**STAFF REPORT**  
**COMMUNITY DEVELOPMENT DEPARTMENT**

HEARING DATE: 7/13/2021  
TO: Mayor & City Council  
FROM: Joseph Dodson, Associate Planner  
208-884-5533  
SUBJECT: FP-2021-0039  
Oaks North No. 11  
LOCATION: Generally located at 5685 N. Black Cat Rd., in the SW ¼ of the NE ¼ of Section 28, T.4N., R.1W.

Request for Final Plat consisting of 30 single-family residential building lots and 5 common lots on 9.99 acres of land in the R-4 zoning district, by Toll Southwest, LLC.

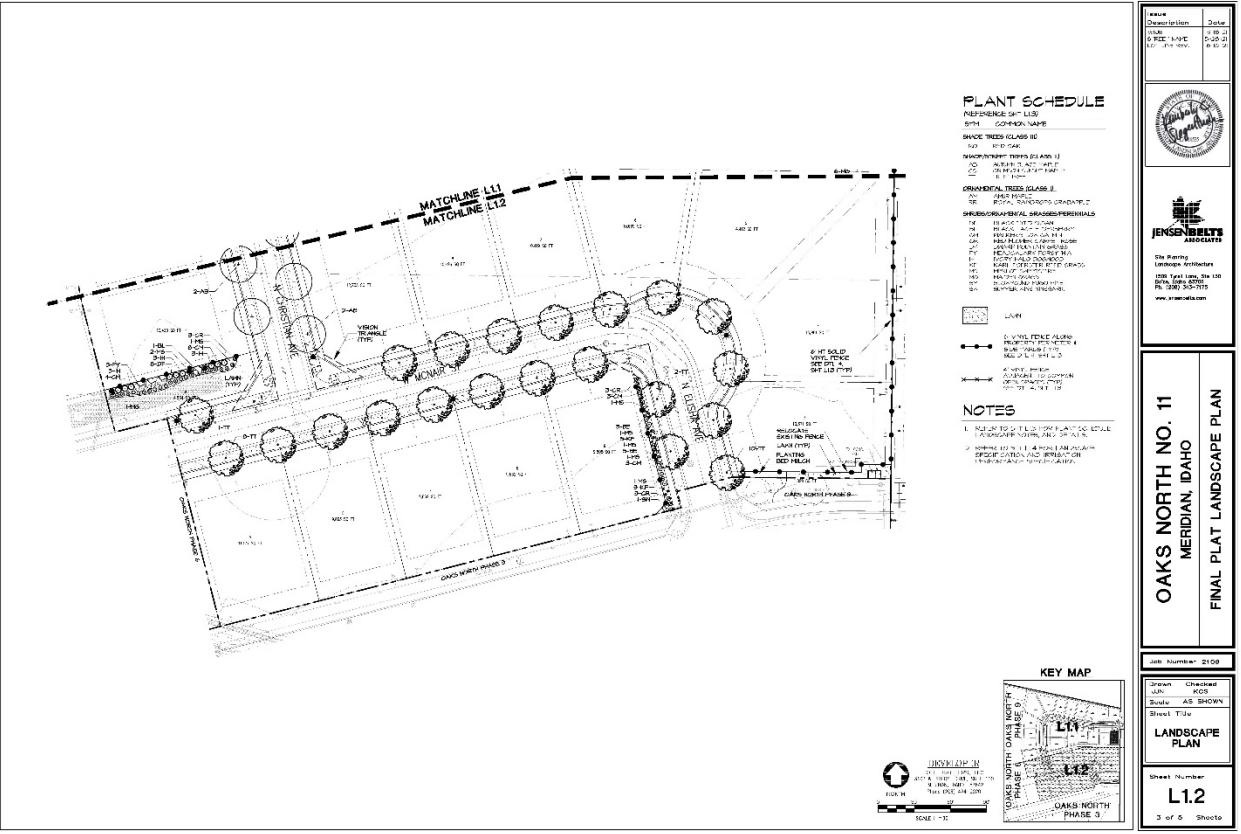
3. Prior to submittal for the City Engineer's signature, have the Certificate of Owners and the accompanying acknowledgement signed and notarized.
4. The final plat shown in Section V.B prepared by Land Solutions, stamped on 06/09/21 by Clinton W. Hansen, is approved with the following revisions:

- a. Note #10: Include recorded instrument number.
  - b. Note #12: Include recorded instrument number.
  - c. Add the appropriate Book and Pages for the noted Oaks North Subd. No. 9.

- d. Add a note stating the plat is subject to the provisions contained within the applicable Development Agreement.
5. The landscape plan shown in Section V.C prepared by Jensen Belts Associates, dated 05/18/21, is approved as submitted.
